REMARKS

This is in response to the Final Rejection in the Office Action mailed February 1, 2006

TITLE: BUMPED DIE AND WIRE
BONDED BOARD-ON-CHIP PACKAGE
Inventor: Larry D.Kinsman
Serial No. 10/792,229
Docket No. 2269-4585.3US
ANNOTATE SHEET SHOWING
CHANGES

Fig. 6

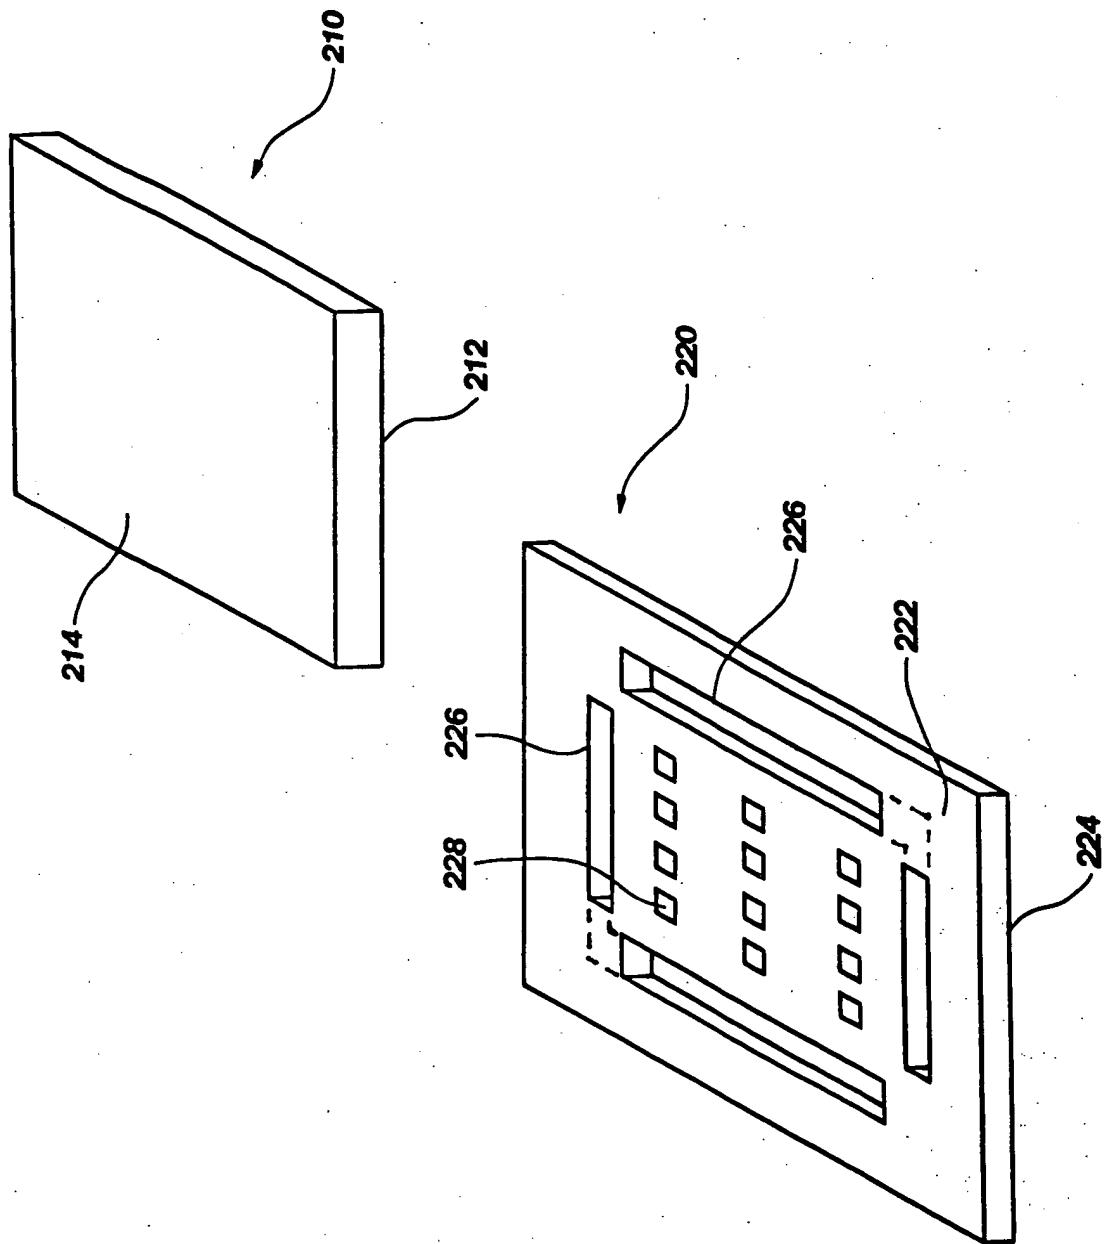
The attached sheets of drawings include changes to FIG. 6. This sheet, which includes FIG. 6, replaces the previous drawing sheet, including FIG. 6. In FIG. 6, previously omitted at least one opening 226 of the substrate 220 of the at least one semiconductor assembly extending proximate more than one side of a periphery of the substrate 220 has been illustrated by the dashed lines extending from one opening 226 proximate one side 220 of the periphery of the substrate to another opening 226 proximate another side of the periphery of the substrate 220. (See attached Replacement Sheet and Annotated Sheet Showing Changes.)

Applicant asserts that presently amended independent claims 16 and 17 as well as dependent claim 18 therefrom clearly comply with the provisions of 35 U.S.C. § 112, second paragraph, as the subject matter is clearly illustrated in the corrected drawing FIG. 6 as particularly pointing out and distinctly claiming the subject matter which applicant regards as the invention.
